Subject: WHITE MILKY STAINS ON INNER SURFACE OF HEADLIGHT LENS	Bulletin No: 09-014/16
	Last Issued: 02/26/2016

2013-2016 CX-5 vehicles with VINs between JM3KE*****486578 - 745219 (produced between May 28, 2014 and Nov. 23, 2015)

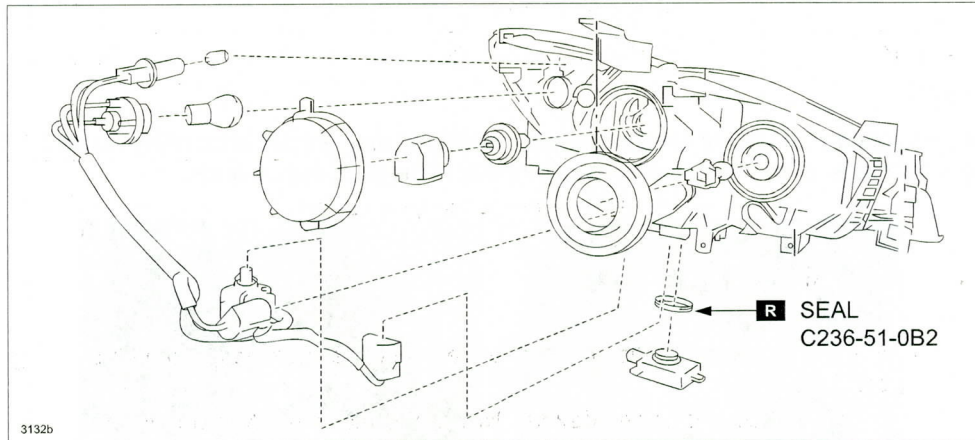
Some vehicles equipped with LED or Discharge type headlights may exhibit white milky stains on the inner surface of the headlight lens. Some customers may complain of the poor appearance.

This concern is caused by gas that emits from a gasket in the lamp unit. The gas adheres to the inner surface of the headlight lens and reacts with the anti-clouding coating and moisture in the air to create white milky stains.

The gasket material has been improved to eliminate this concern.

2. Replace the affected head lamp unit(s) with modified parts according to the instructions on MS3 online or the Workshop Manual (section 09-18 FRONT COMBINATION LIGHT REMOVAL/INSTALLATION).
